City of
GREENFIELD, MASSACHUSETTS

MEMO

Re: Greenfield Library Overview (Leavitt Hovey House)

APPENDIX A
PARTIAL BASEMENT PLAN
OPTION 1

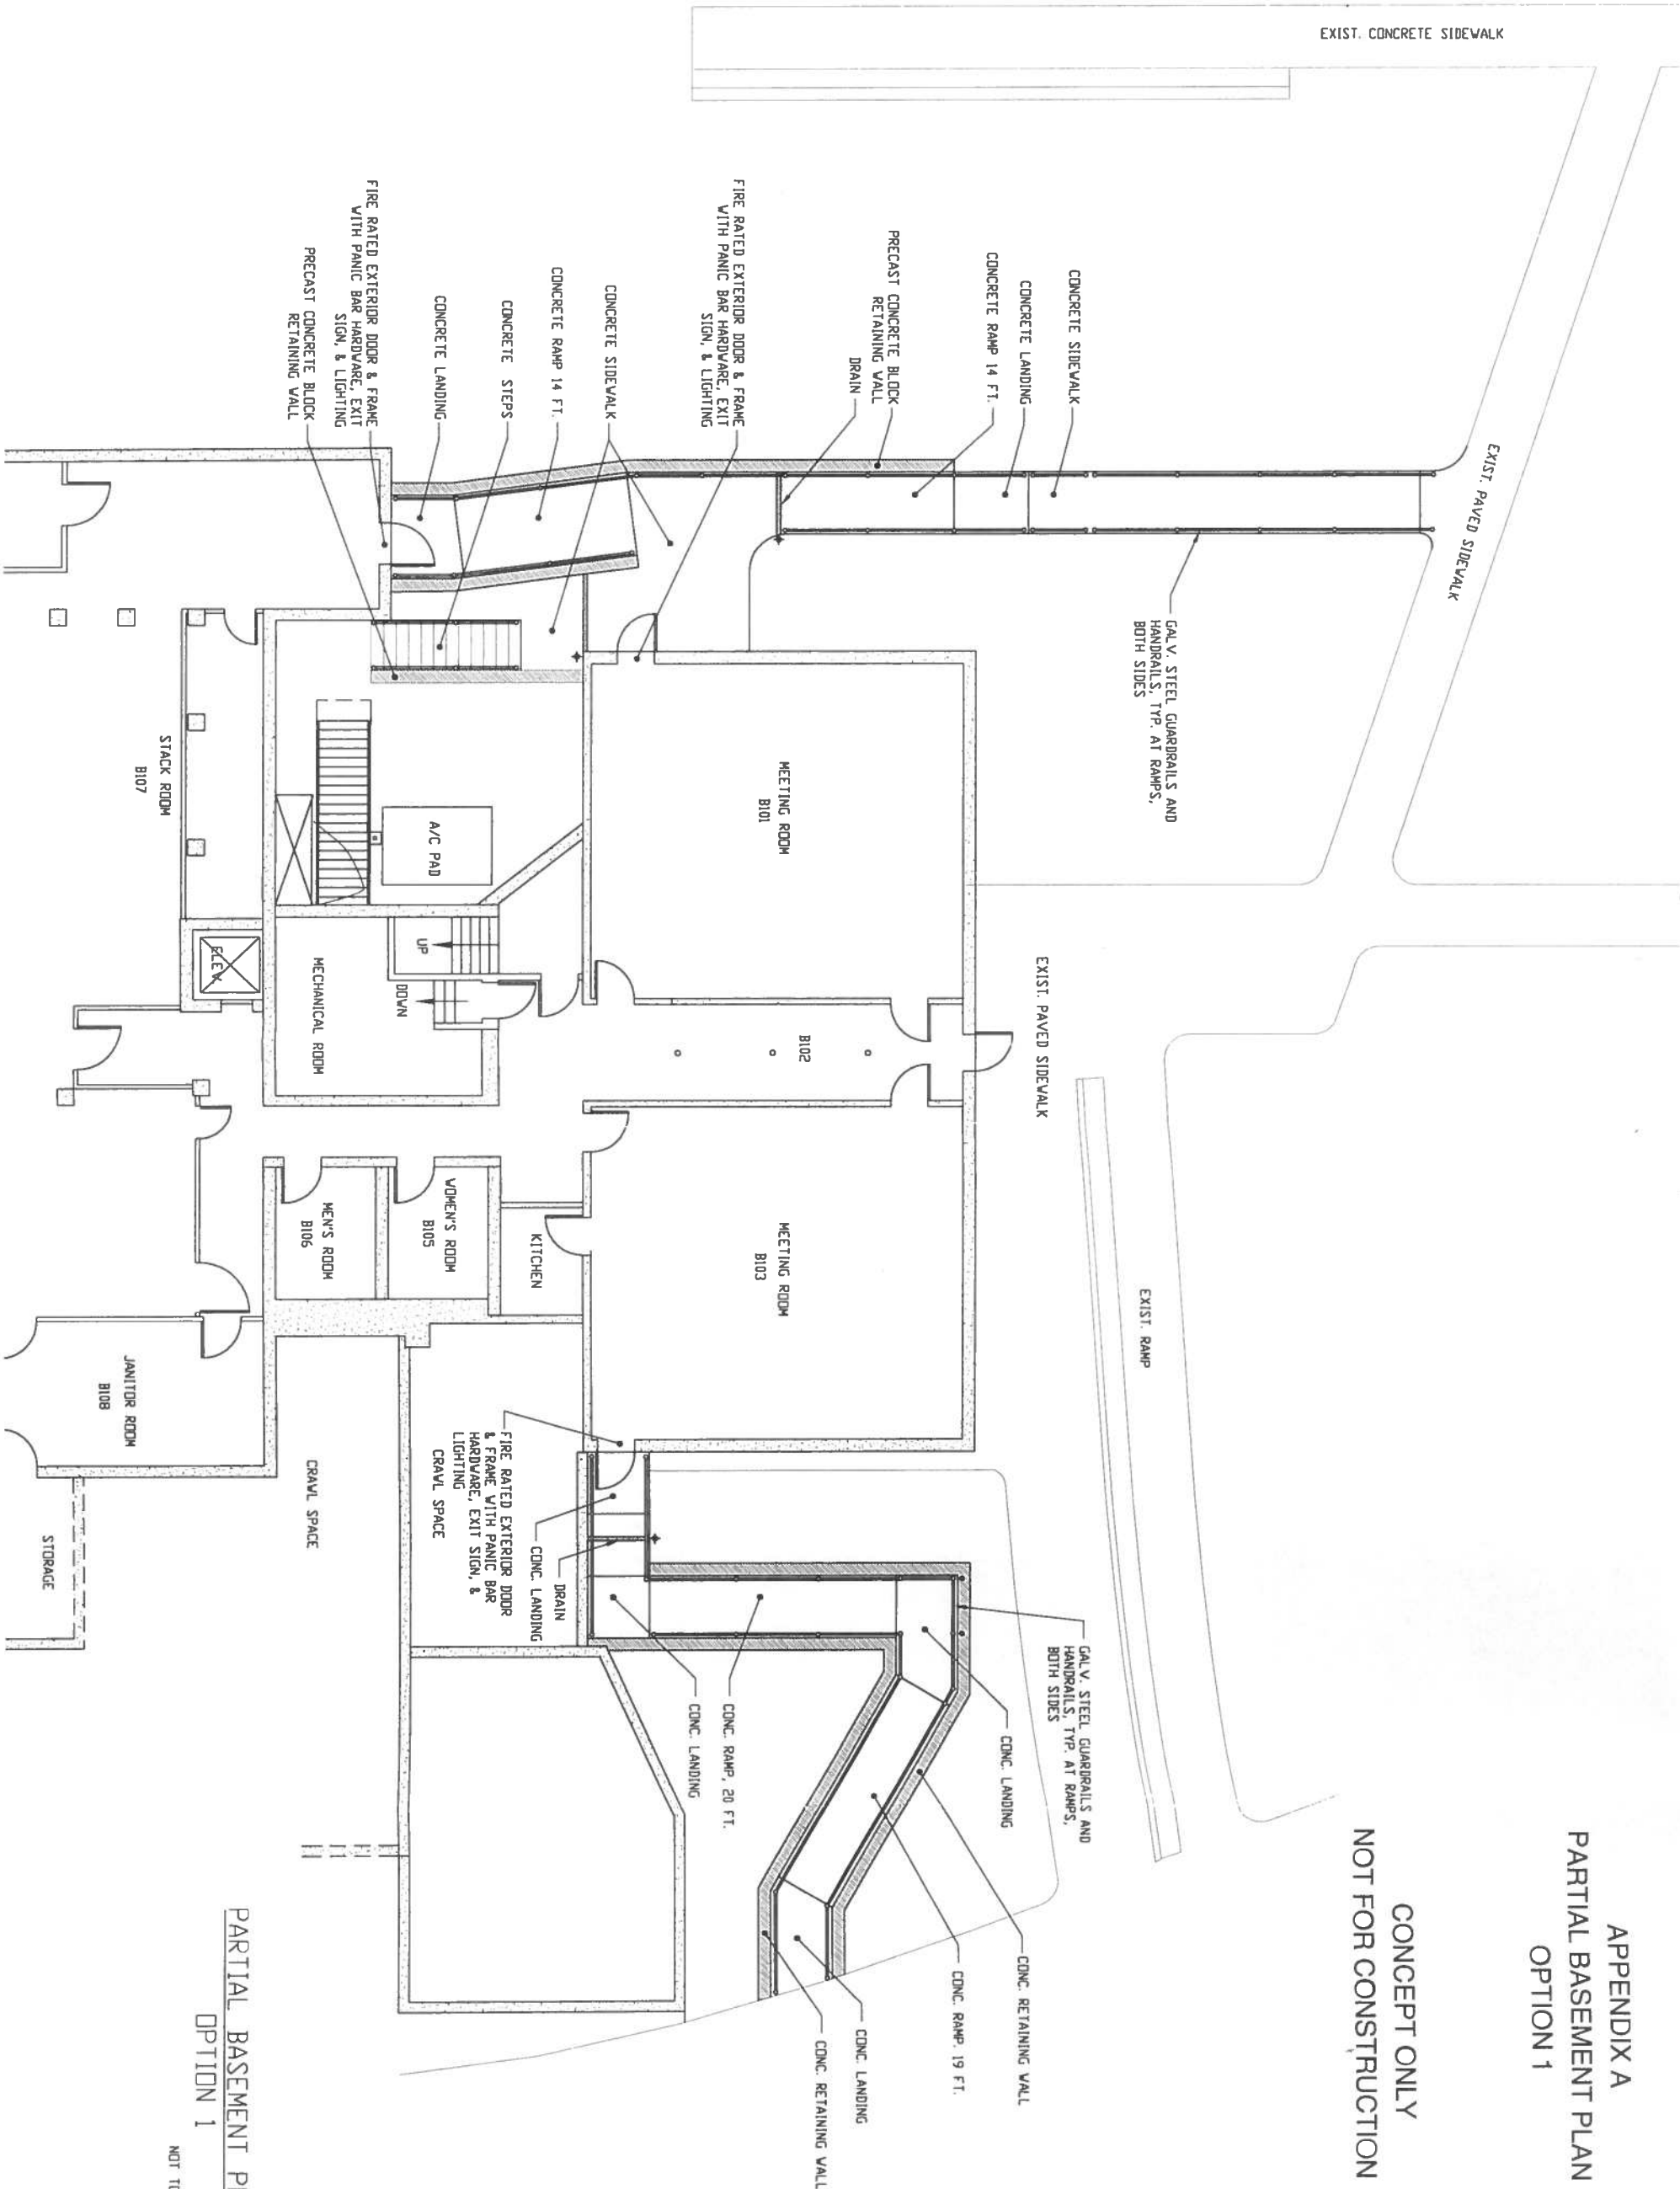
Option 1 (see Appendix A) would create new exit doors at the back of rooms B101 and B102. New retaining walls and accessible ramps would be built to on the eastern and western sides of the addition for egress to safe discharge areas. On the west side, the stack room egress stairs would be eliminated and the exit would discharge to a ramp intersecting with the B101 ramp. The approximate cost for this option would be \$86,000. The additional cost for an engineer or architect to design the modifications would be about \$20,000.

PARTIAL BASEMENT PLAN
OPTION 2

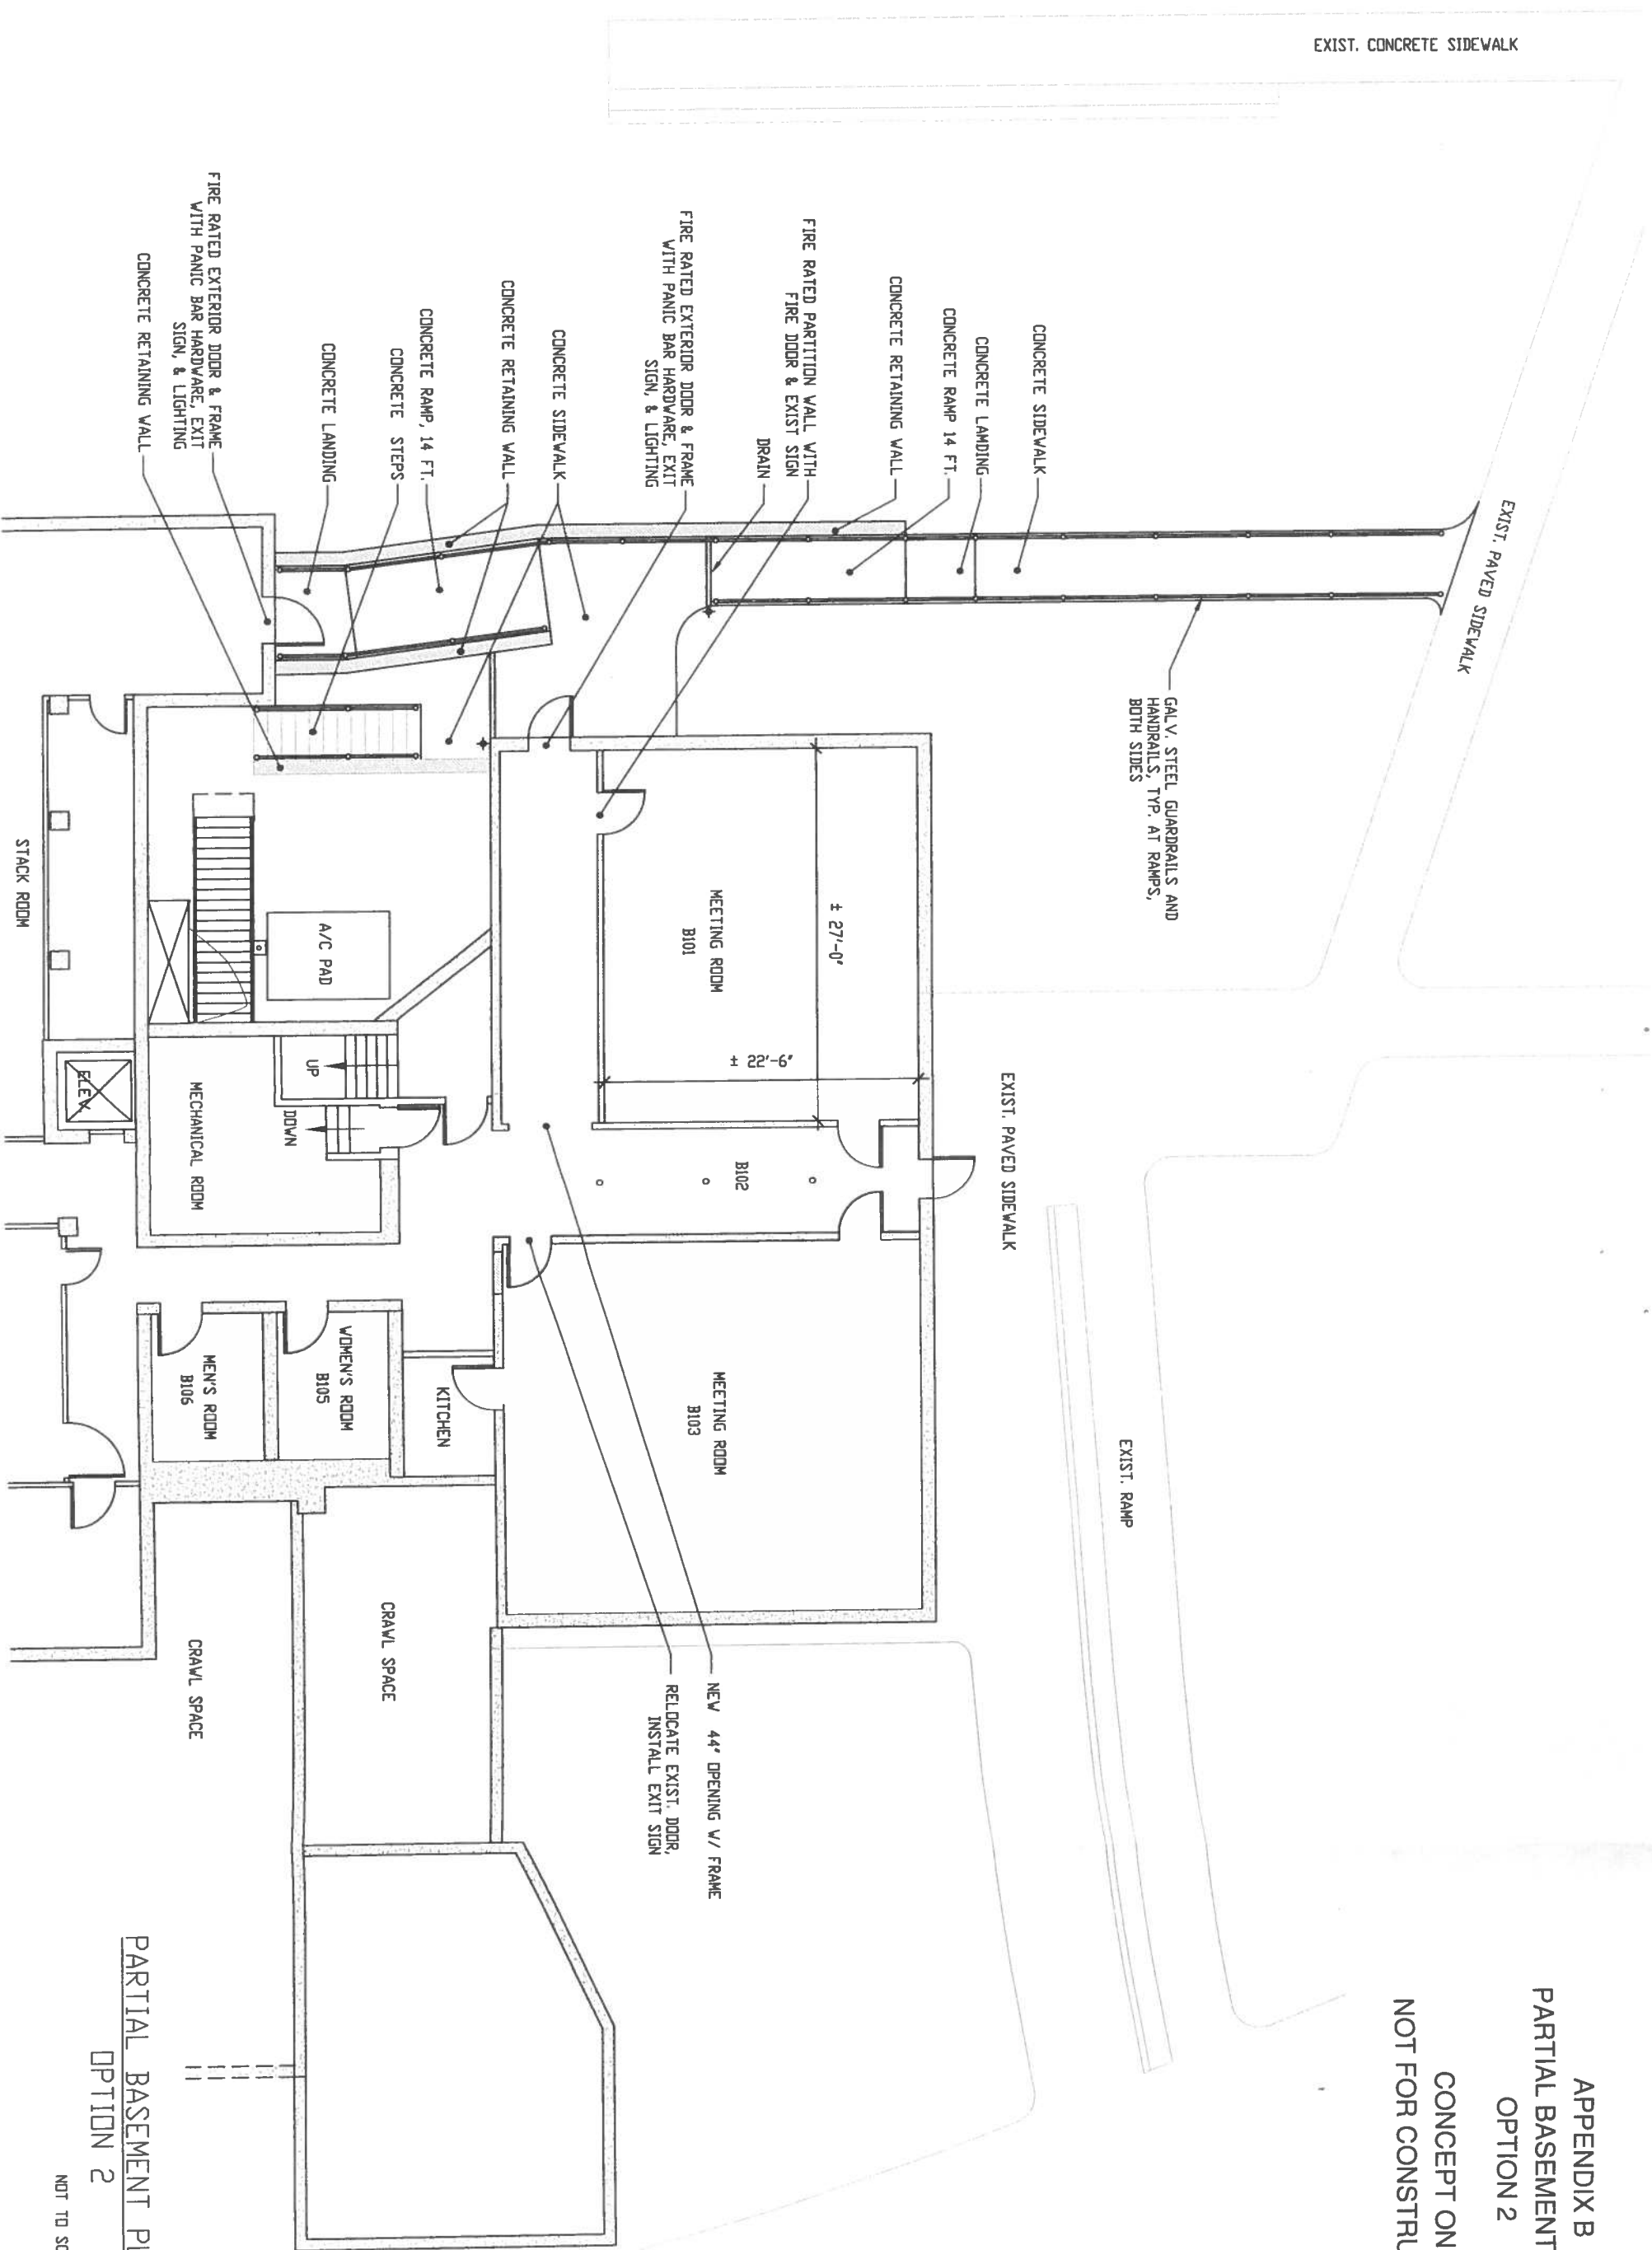
In order to make the library safe for all patrons, two options were considered. Option 1 provides egress from B101 and B103 to the exterior directly. Option 2 is less expensive. It provides egress from B103 through B101, and reduces the floor area of B101 by about 25%. Both options provide a compliant means of egress from the stack area.

Picture 1

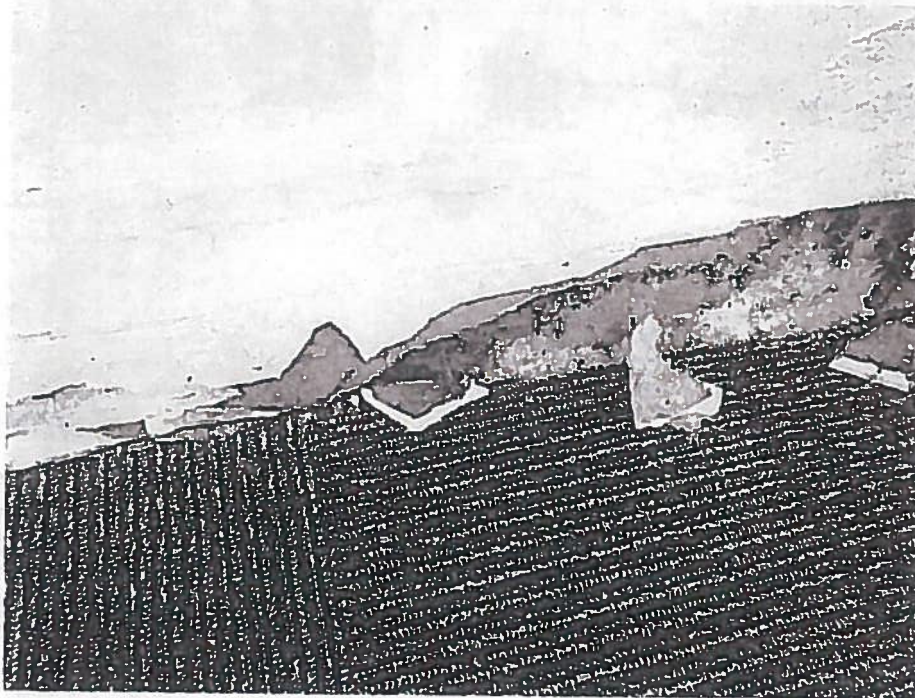
Room B101 had extensive water damage along its western wall (Picture 1). It also appears that repairs were attempted in the past in the form of gypsum wallboard (GW) patches used to fill holes in the base of the plaster wall (Picture 2), as indicated by the presence of paper inside the wall. The use of GW as a patch is inappropriate since the paper backing can become mold-colonized if chronically wet. The likely source of moisture causing this damage is pooling water against the foundation. Cement slabs were placed against the foundation to form a walkway and provide some amount of water drainage from the building. Chronic exposure to

Room B101 had extensive water damage along its western wall

1. Consider implementing recommendations in the 2002 report that have not already implemented. A copy of the 2002 report is attached as Appendix A.
2. Remove GW used to repair the basement wall in B103. Repair with an appropriate material (e.g., cement board) that is not susceptible to mold growth.
3. To prevent future water damage from rain/groundwater in basement rooms a number of options to improve drainage from the west-facing wall of the 1907 building can be considered:
 - Install a French drain at the base of the wall;

Picture 3

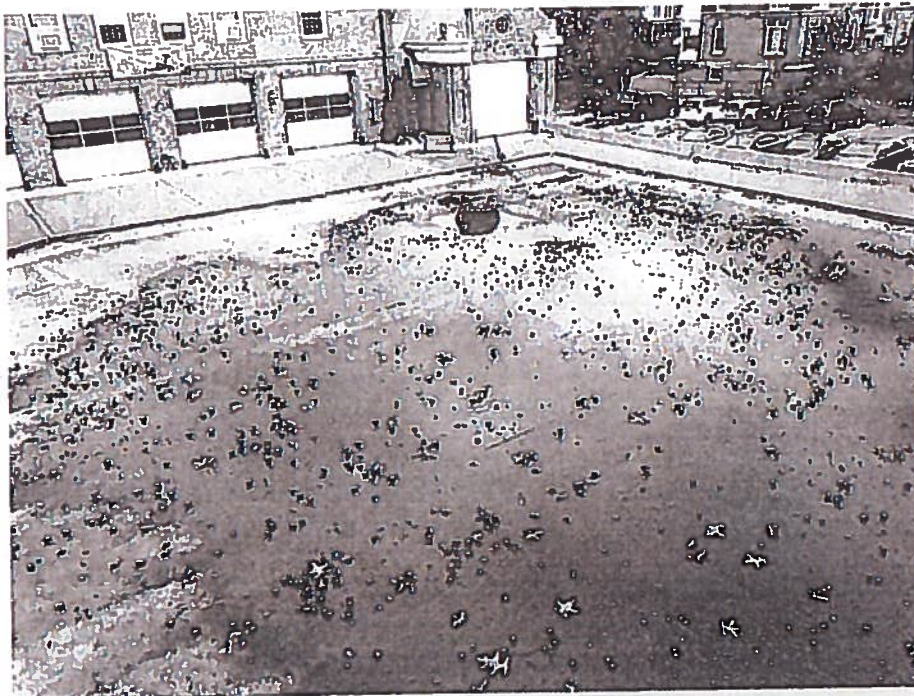
**Subsiding and ajar cement slabs at base of west wall
(Note missing sealant in slab/wall junction)**

Picture 4

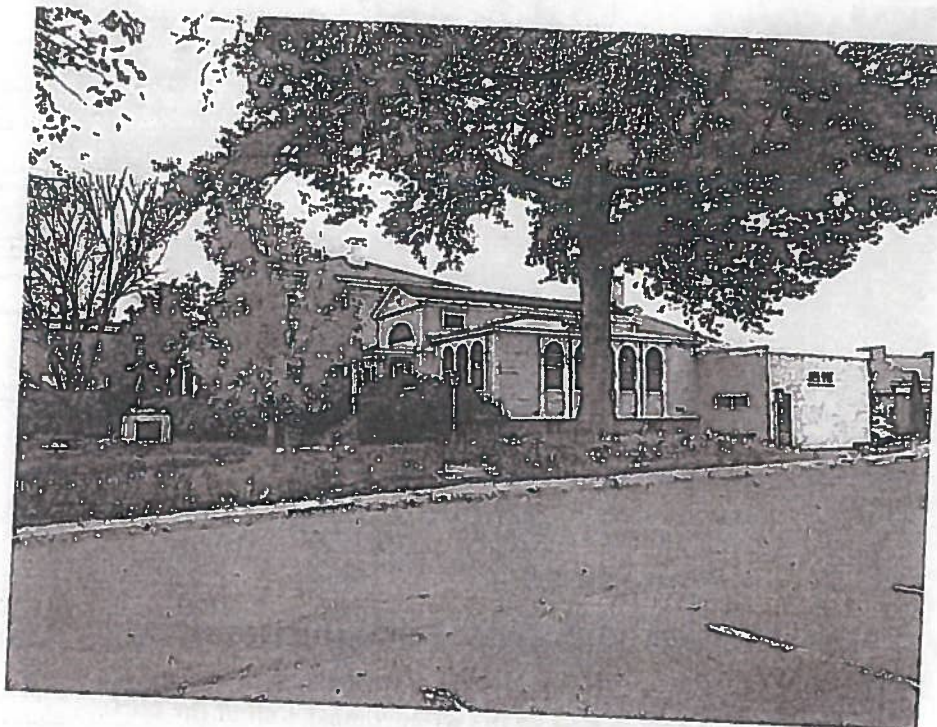
Pooling water on roof

Picture 5

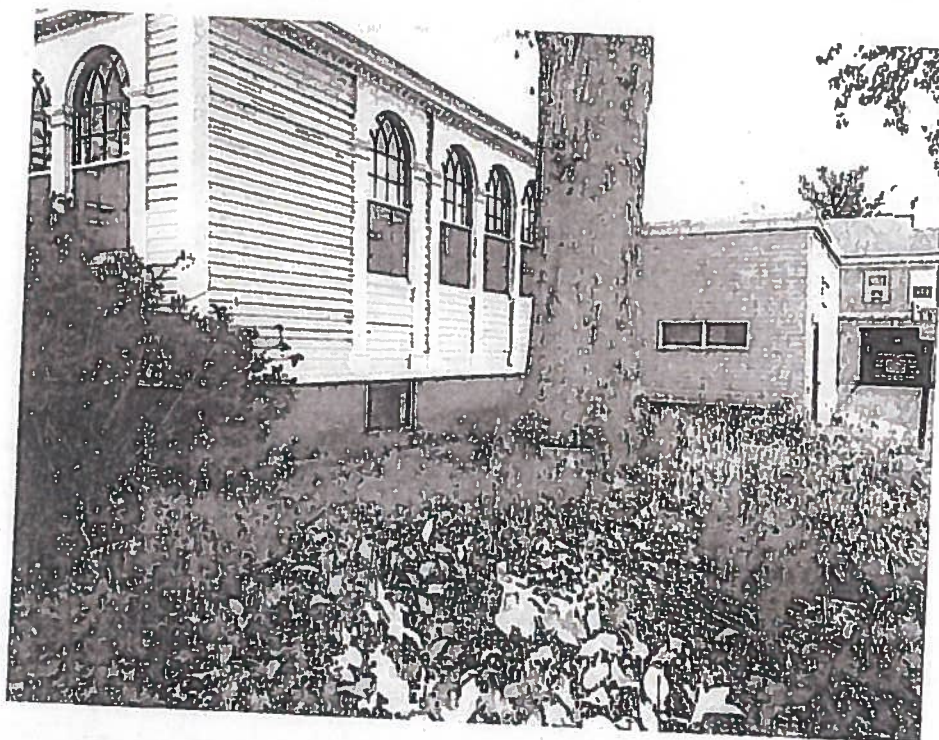
- The oak tree prevents sunlight from drying the eastern wall of the GPL.
- The oak tree is a possible danger to the GPL due to its distance from its exterior walls. The recommended safe distance from which an oak tree should be planted is recommended to be approximately 98 feet (33 yards) from the exterior of a building (BI, 2015). Soil subsidence may also be caused by oak tree roots, which can undermine the structure of a building to cause wall and floor cracking as well as other related damage. To prevent subsidence, a 98 feet distance is recommended (Williams, A. 2006). Within this distance, severe weather may

Oak tree overhanging building

4. It is highly recommended to remove the oak tree from the southwest corner of the building to improve roof drainage and prevent potentially catastrophic damage in severe wind conditions/heavy rain.
